TECHNICAL SERVICE BULLETIN

Classification:	Reference:	Date:
BT22-026	ITB22-044	December 16, 2022

LICENSE PLATE BRACKET INSTALLATION ON FRONT FASCIA

APPLIED VEHICLES: 2022 QX55 (J55)

Figure 1

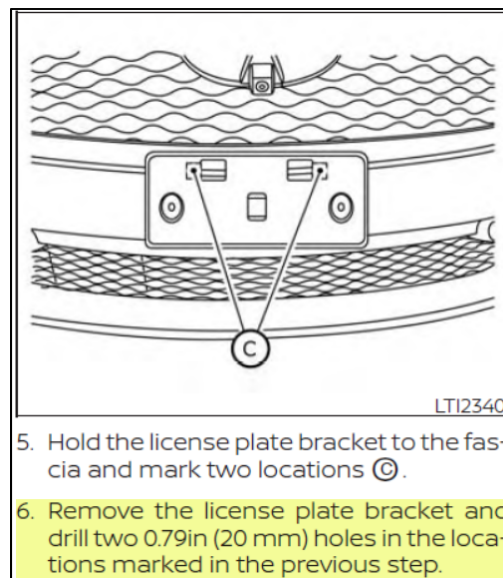
When performing step 6 of the license plate bracket installation instructions in the owner's manual, it is critical to maintain a 0.79 in. (20 mm) hole when drilling locations © (Figure 1). If a 0.79 in. (20 mm) hole is not maintained, the license plate bracket will not sit flush on the front fascia.
